TITLE: **VOLCANO CLIFFS ARSENIC TREATMENT FACILITY AND PUMP STATION UPGRADES PROJECT OVERVIEW**

Project # PR-2023-008617
SI-2023-00866 - Site Plan - EPC, Major Amendment

On June 15, 2023 the Environmental Planning Commission (EPC) voted to Approve Project # PR-2023-008617, SI-2023-00866 - Site Plan – EPC, Major Amendment) based on the following Findings and subject to the following Conditions of Approval:

RE: Request for a Site Plan – EPC DFT Sign-Off
PR-2023-008617

**LANDSCAPE
 PLAN**

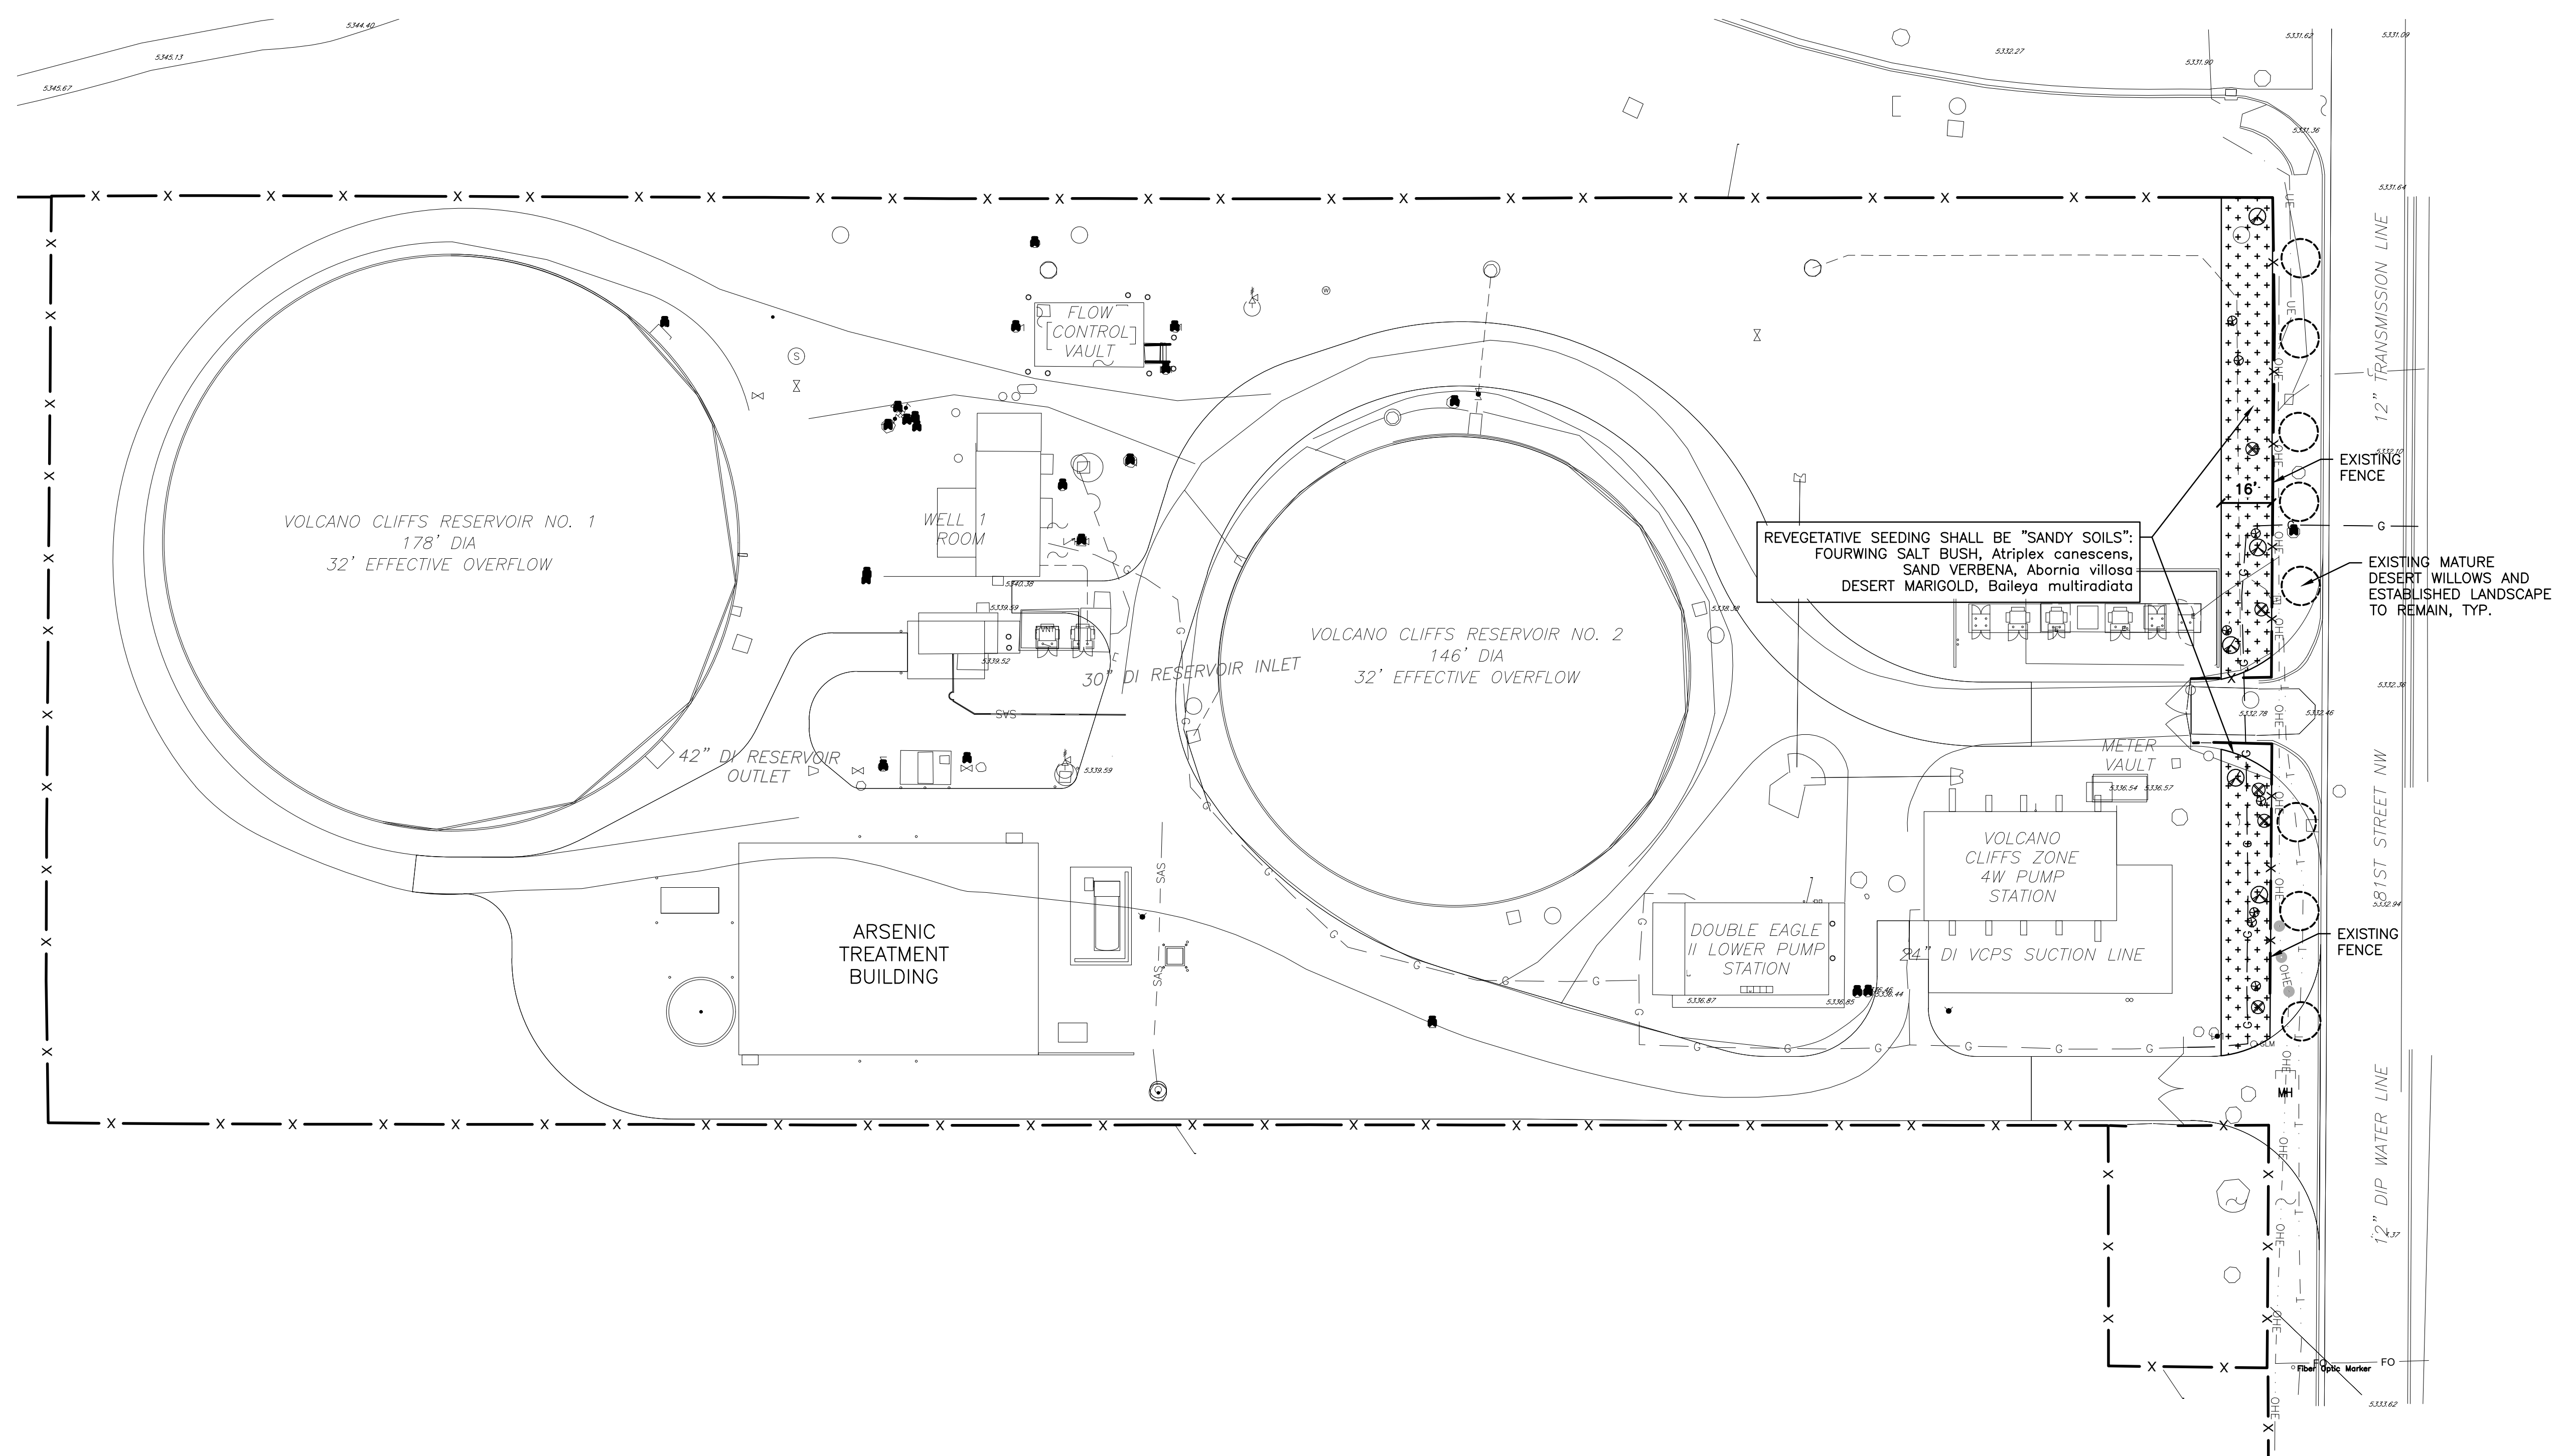
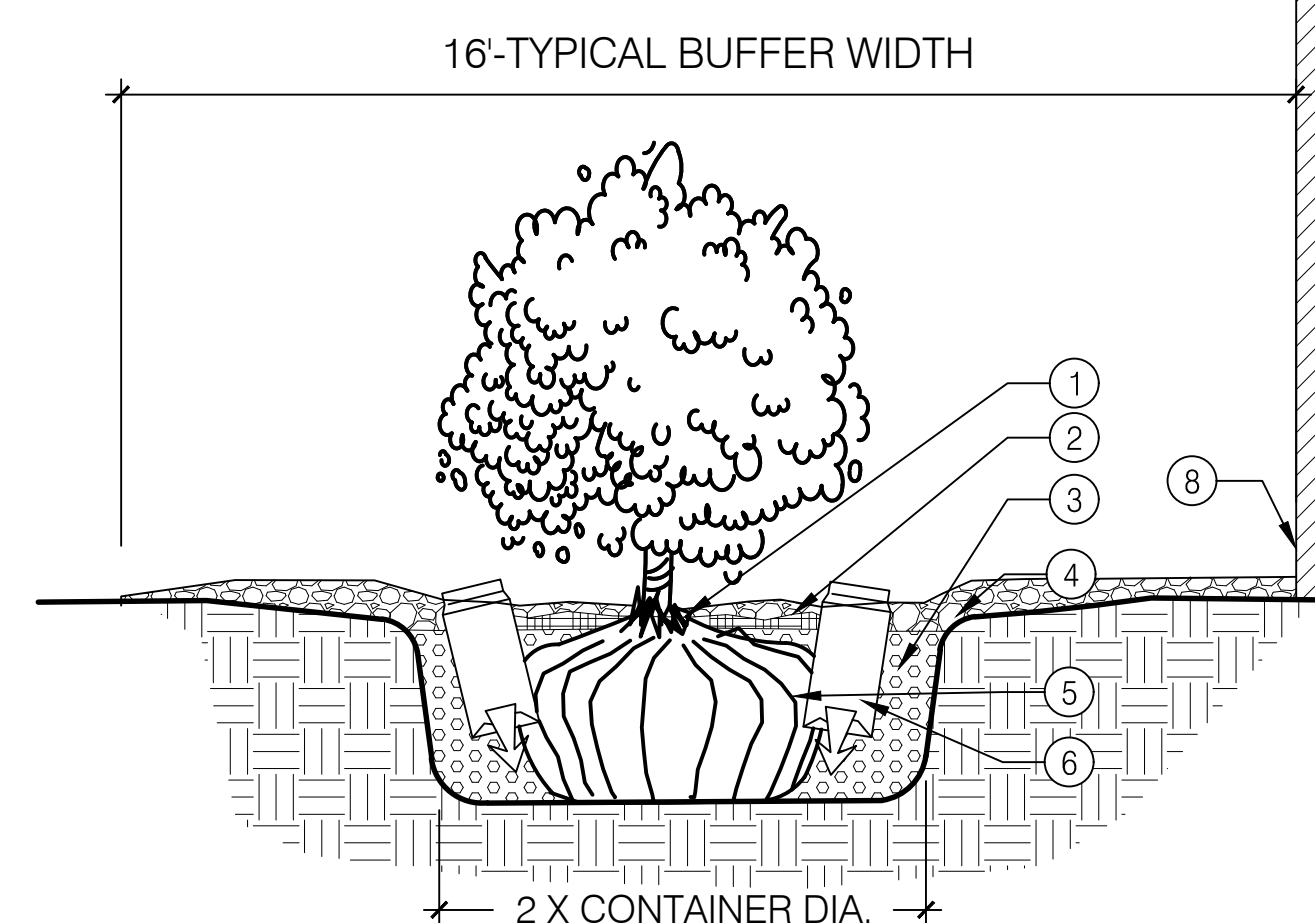
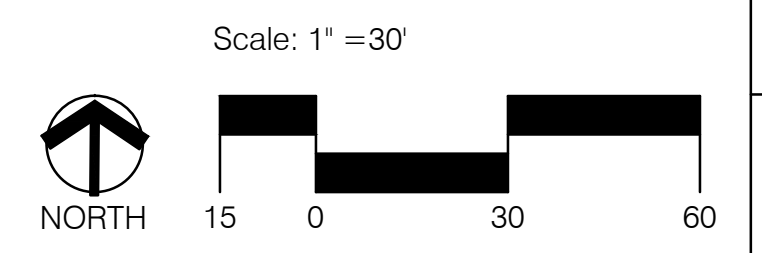
4. The applicant shall ensure that new shrubs are watered sufficiently as per the General Landscape Notes found in the Landscape Plan (LS 100).
5. Details shall be provided for the Evaporative Cooler, CO2 Tank and Surge Tank enclosure/screen walls.

Condition # 4: The applicant shall ensure that new shrubs are watered sufficiently as per the General Landscape Notes found in the Landscape Plan (LS 100).

Applicant's Response: Agreed.
